Sub: Proposal for seeking prior approval of the Central Government under Section 2(ii) of the Forest (Conservation) Act, 1980 in favour of M/s Odisha Coal & Power Ltd (OCPL) for non-forestry use of 342.87 ha of forest land for development of Dip Side Manoharpur Coal Mining Project in Sundargarh District of Sundargarh Forest Division, Odisha - Compliance to Gol observations regarding.

Sub: Minutes of Meeting (MoM) of "Advisory Committee" (AC) meeting dated 14th November 2023 on Agenda No.10 - Forest Diversion Proposal of 342.870 ha of Forest land for development of Dip-Side Manoharpur Coal Mining Project in Sundargarh District of Odisha Coal & Power Ltd (OCPL), Bhubaneswar (Online Proposal no. FP/OR/MIN/37631/2018).

Reg- Essential Details Sought (EDS) letter dated 27.11.2023 of Dy. Inspector General of Forests, MoEF&CC, New Delhi on the decision of the Advisory Committee for detailed review by State on the 51.64 ha Forest land proposed to be used for dumping.

Note on review of 51.64 ha forest land requirement for external over burden dumping at Manoharpur & Dip Side of Manoharpur Coal Mine Project (Expansion of Manoharpur Coal Mine – 8.0 to 16.0 Million Te per Annum) of Odisha Co

Position of Forest Land (51.64Ha) in External OB Dump

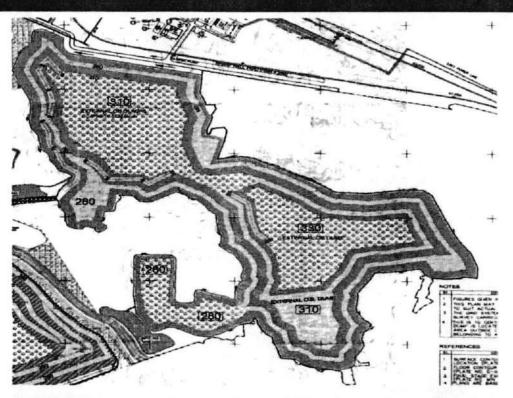
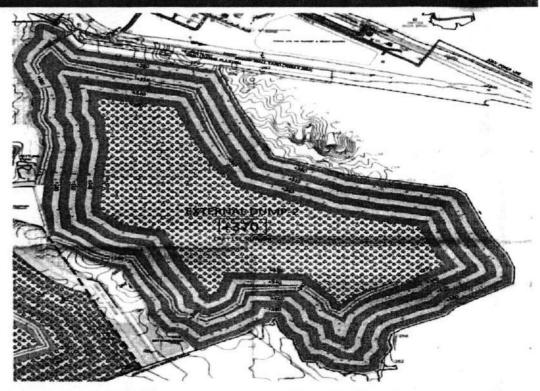
forest patch is essential ,to increase the dump height from 60 mtr to maximum height(120m).
